**Before the
FEDERAL COMMUNICATIONS COMMISSION
Washington, D.C. 20554**

In the Matter of)	
)	
Row 44, Inc.)	
)	
Application For Authority To Operate Up)	FCC File No. SES-LIC-20080508-00570
To 1,000 Technically-Identical)	Call Sign: E080100
Aeronautical-Mobile Satellite Service)	
Transmit/Receive Earth Stations)	
Aboard Commercial And Private Aircraft)	
)

REPLY OF VIASAT, INC.

Two-Way Fuselage Mount Antenna Transmit Gain

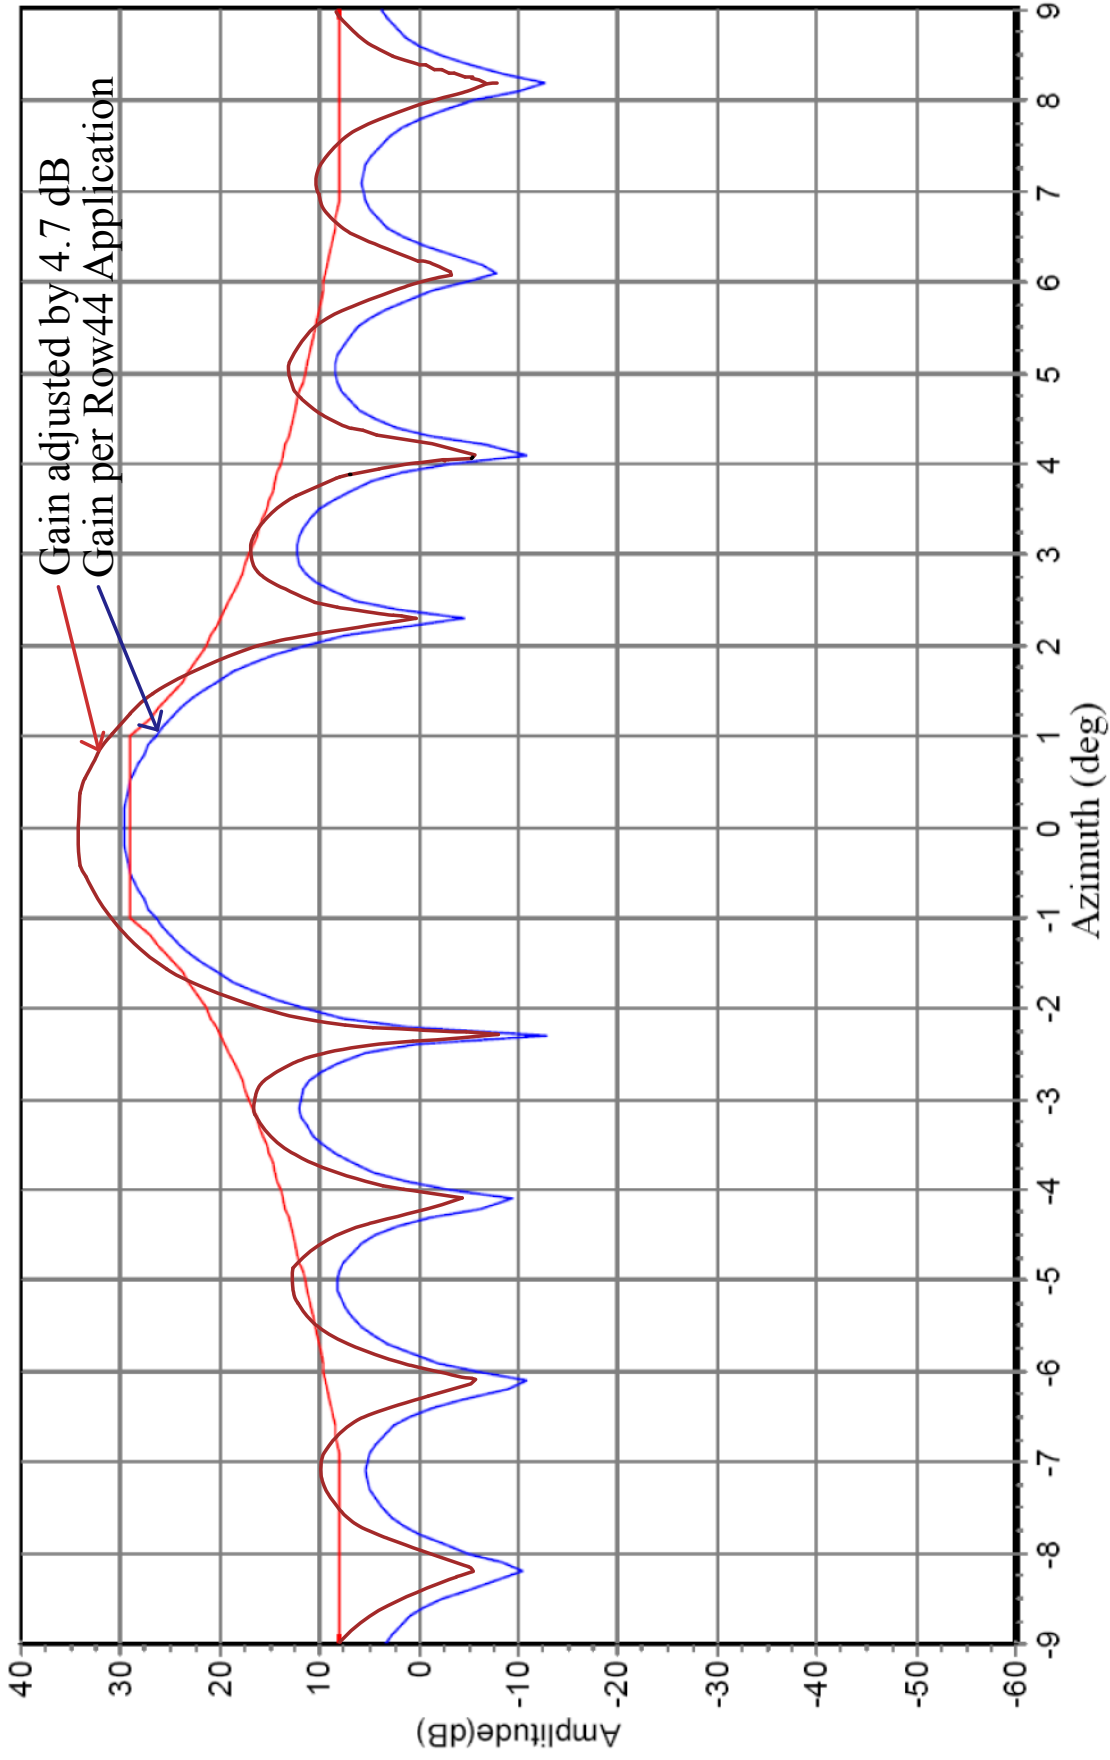
Row 44's approach has the effect of artificially depressing the antenna gain reported in the Application. As shown in Exhibit 1, when calculated using the standard methodology based on specifications published by the manufacturer of the proposed antenna (Aerosat), Row 44's transmit antenna gain is not compliant with the Section 25.209 antenna mask.⁴¹ Notably, Row 44 seeks no waiver of Section 25.209. Further, to the extent that Row 44 seeks to rely on this "line loss" to reduce the expected power level that would be input to the antenna, Row 44 fails to explain whether this line loss is representative of each application of its technology, or whether the length of the "transmit flexible-waveguide structure" that produces this loss would vary among the different aircraft types that may utilize the Row 44 system.

The 4.7 dB adjustment value is the difference between the 33.3 dBi gain specified in marketing materials released by the manufacturer (Aerosat) and the 28.6 dBi gain provided by Row 44 in the Application.

14.3 GHz Elevation Vertical Polarization

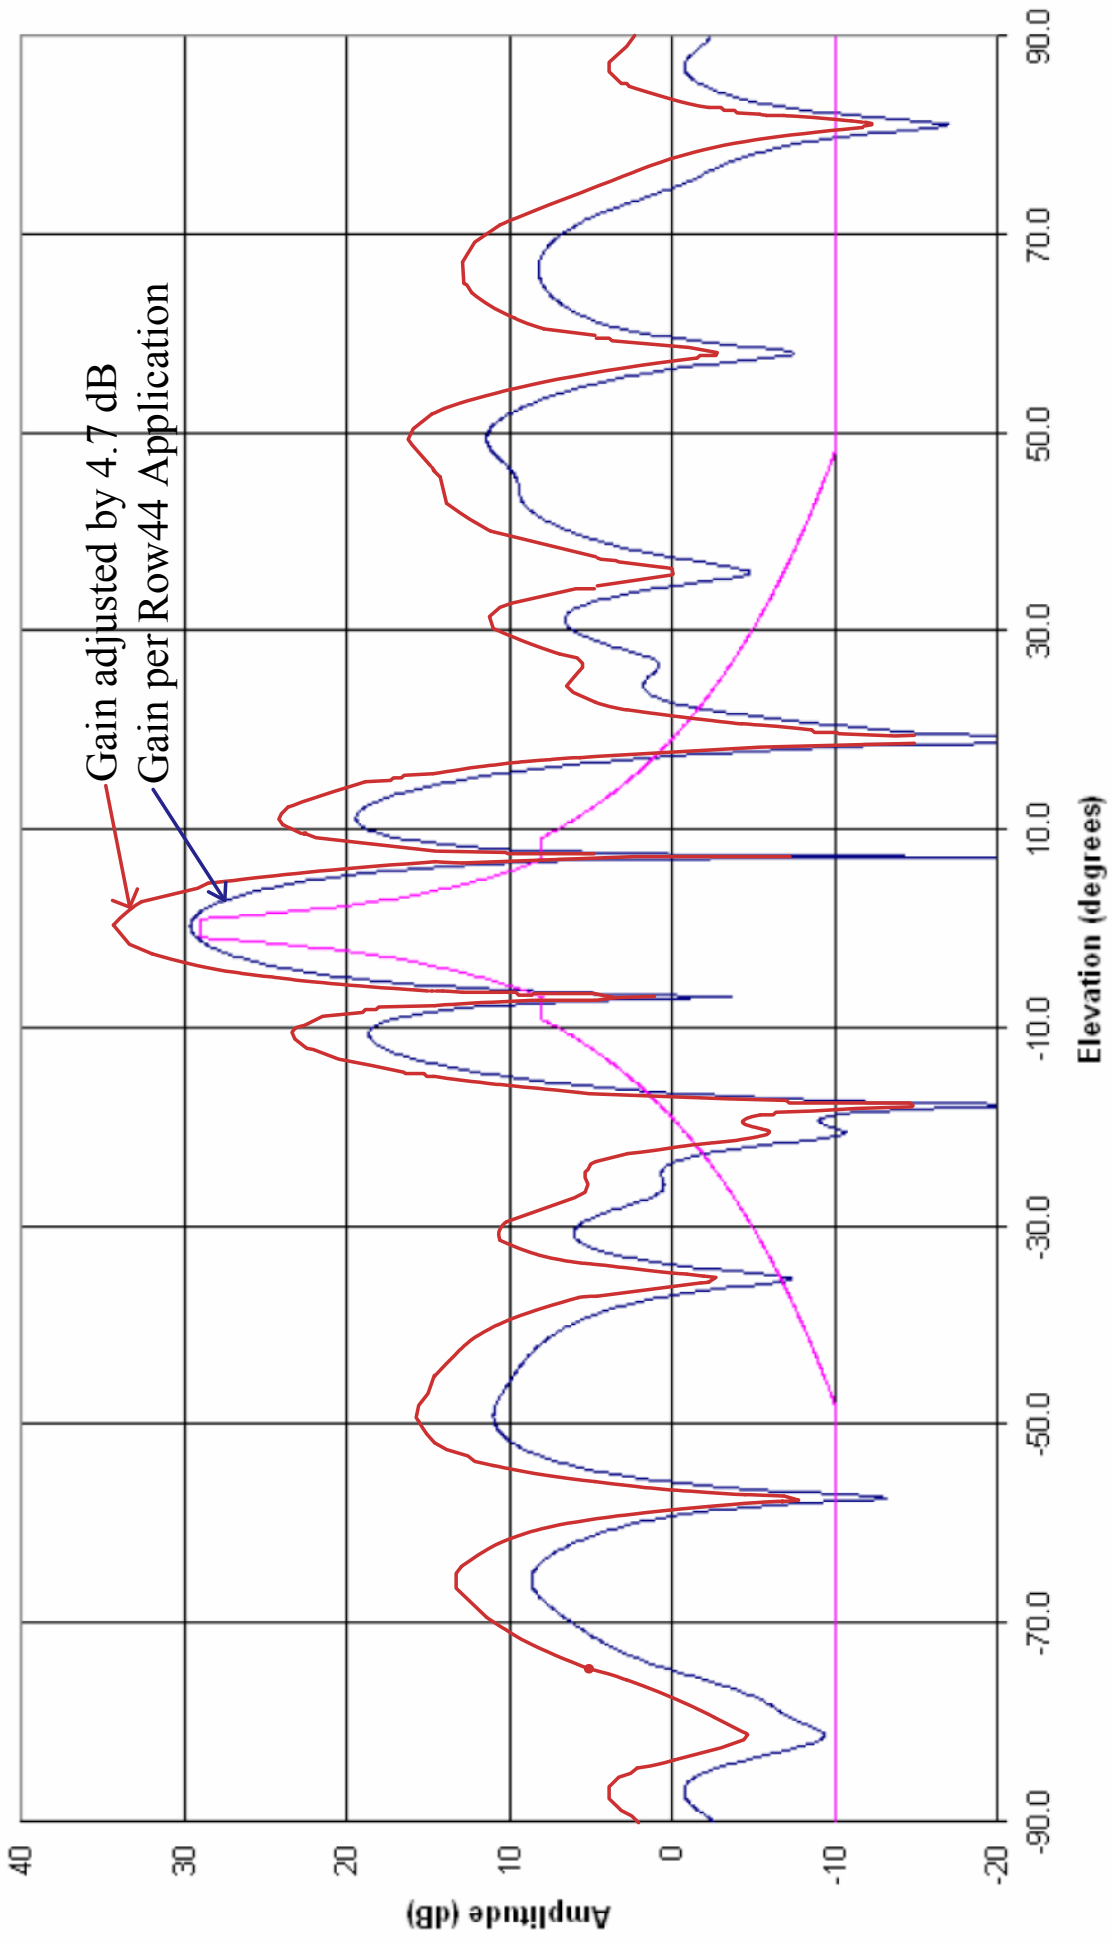
The 4.7 dB adjustment value is the difference between the 33.3 dBi gain specified in marketing materials released by the manufacturer (Aerosat) and the 28.6 dBi gain provided by Row 44 in the Application.
